STAFF REPORT AND RECOMMENDATION TO THE DESIGN COMMISSION

CASE FILE: LU 15-102181 DZM
PC # 13-235106
SE 9th & Belmont Apartments
REVIEW BY: Design Commission
WHEN: Thursday June 11, 2015 at 1:30 PM
WHERE: 1900 SW Fourth Ave., Room 2500A
Portland, OR 97201

9TH AND BELMONT - LU 15-102181

WEST ELEVATION

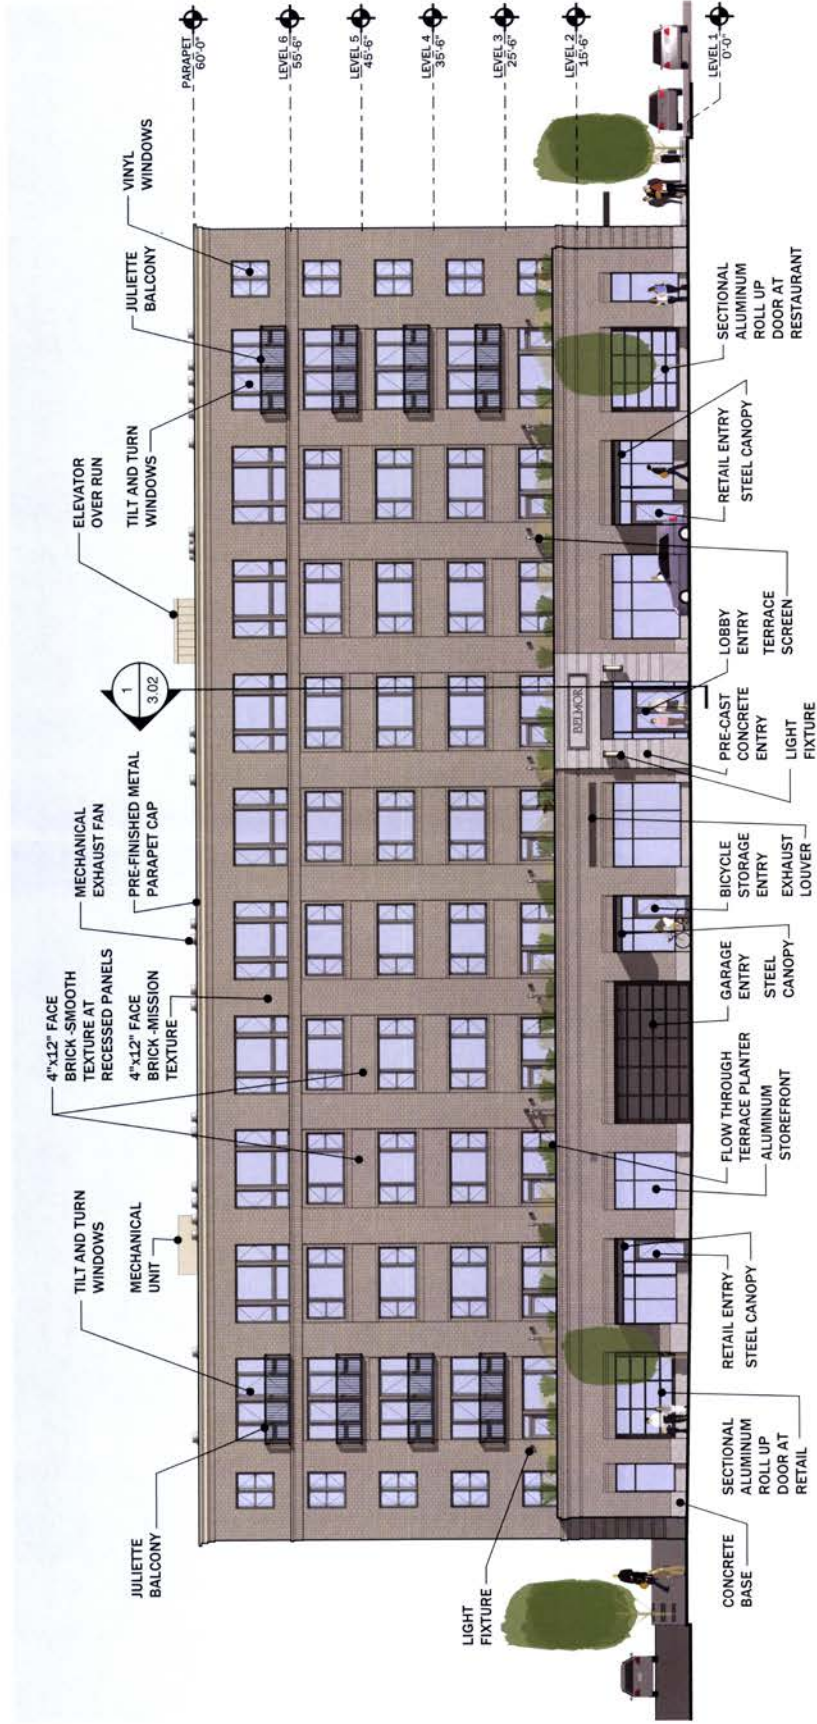
- *Building Ground Level Setback.* The building is set back from the SE 9th Avenue lot line due to clearance requirements from overhead Pacific Power high-voltage supply lines that run through this neighborhood. While the recessed upper stories creates an interesting ground floor podium, Staff believes that the pulled back corners of the ground floor make this one story podium seem like an attachment instead of a strong, cohesive base for the building. A more approvable design could carry this podium, perhaps at two-stories to match the adjacent Grand Central Bowl building height. If the taller podium was carried around all three sides, additional outdoor spaces could also be provided for the north and south 2nd floor units as well as providing a stronger contextual massing response to adjacent building scales. Staff believes that the podium and tower portions of the building need further integration to create a cohesive composition.

- *Ground Level Storefront Patterning and Arrangement.* The ground level window types, interspersed with overhead doors, the garage door, the main entry surround, and recessed retail entries, create a variety of mullion patterns and window widths that do not contribute to a cohesive façade around the building base. Staff believes that the glazing patterns and divisions should be more consistent around the ground floor. The location of the transformer above-grade and facing SE Morrison Street reduces the amount of possible Ground Floor Windows on this north façade. This in turn alters the overall storefront patterning and introduces exposed CMU block at the street level, which again contributes to the inconsistent ground level composition. Staff believes the building design would benefit with the transformer located below-grade so that a consistent glazing and brick pattern can be achieved on the ground level.

- *Window Styles & Depth.* Staff believes that the windows themselves should be set farther into the exterior wall to create a more warehouse-type look that the applicant is striving for with this design. This may require a different surround closure at the window jambs or may require a different type of windows system that has deeper exterior jambs. Overall, the window style changes on the west elevation are the most successful as they are integrated with balcony placement and recessed wall planes which create additional building dimension across what could be a long and repetitive façade. Staff believes that the window types on the north, south, and east elevations are less cohesive and are therefore less successful with the east elevation windows appearing the most repetitive and flat across this façade. The window patterns around all sides of the building should be more cohesive and be surrounded by articulated planes of brick. The top story windows on the east and west facades are also wider and taller than the stories below which makes the upper floor seem heavier than the lower floors. These windows are also not consistent with the north or south windows, which does not allow for a cohesive composition. Staff believes that these upper window proportions should be adjusted so they are smaller and consistent around the top of the building, more in keeping with traditional warehouse and older apartment buildings in the area as described in the applicant's narrative.

- *Juliette Balconies.* The setting back of the upper stories to accommodate the Pacific Power high-voltage lines along SE 9th Avenue reduces the overall amount of unit floor area. While the step back creates terraces for the 2nd floor tenants, it reduces the potential for either recessed or projecting balconies on the upper floors. Staff does not believe that the juliette balconies provide adequate outdoor spaces for the upper units and that the proposal should strive to provide some useable outdoor areas such as a common roof deck, projecting unit balconies, or recessed unit balconies. Staff believes that deeper unit balconies in place of the juliette balconies would also provide a later of dimension that could break up the long expanses of wall surface, particularly on the building ends and east (rear) wall.

- *Cornice Scale.* Staff feels that the cornice at the top of the building appears short when seen in the renderings and elevations and is not in proportion with the overall mass and traditional architectural style of the building. Traditional brick building cornices can be several feet tall and can project out a foot or more from the building wall as they near the top. Staff believes that the building cornice should be taller and deeper to provide a strong top to this traditional design.

EAST ELEVATION

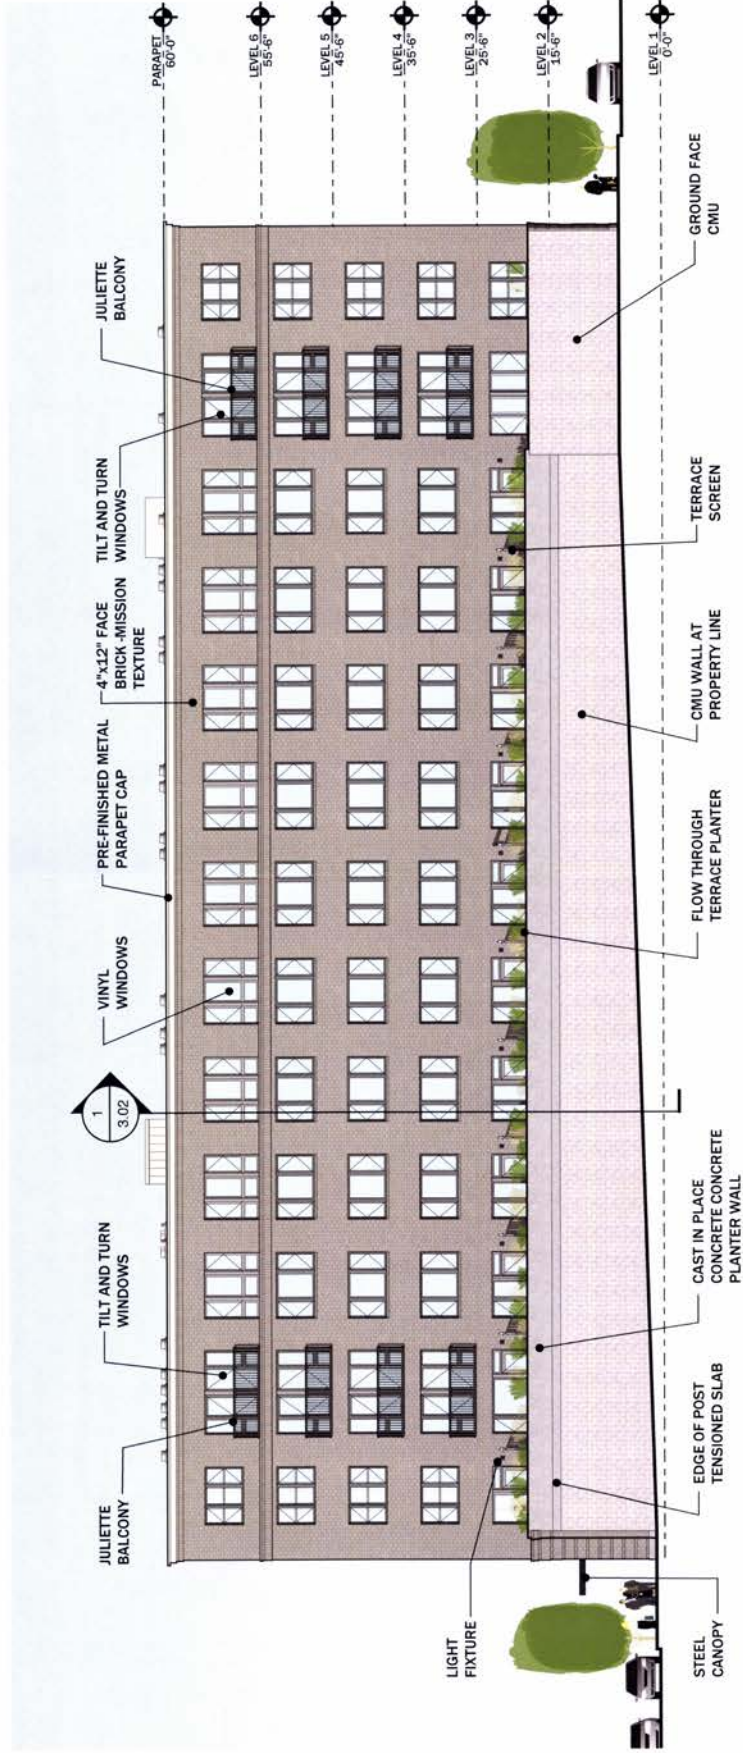
- *East Elevation & Brick Color.* Staff believes that the east elevation appears very flat and is inconsistent with the rest of the building design. The recessed brick patterns surrounding sets of windows on the other elevations could be carried around to this elevation to help break up the repetitive bands of windows.

Additional façade variety could also be achieved with two colors of brick, one for the outer wall planes and one for the recessed planes around the windows. Staff believes that even a subtle color shift would add visual interest to all sides of the building, making the walls appear more dimensional.
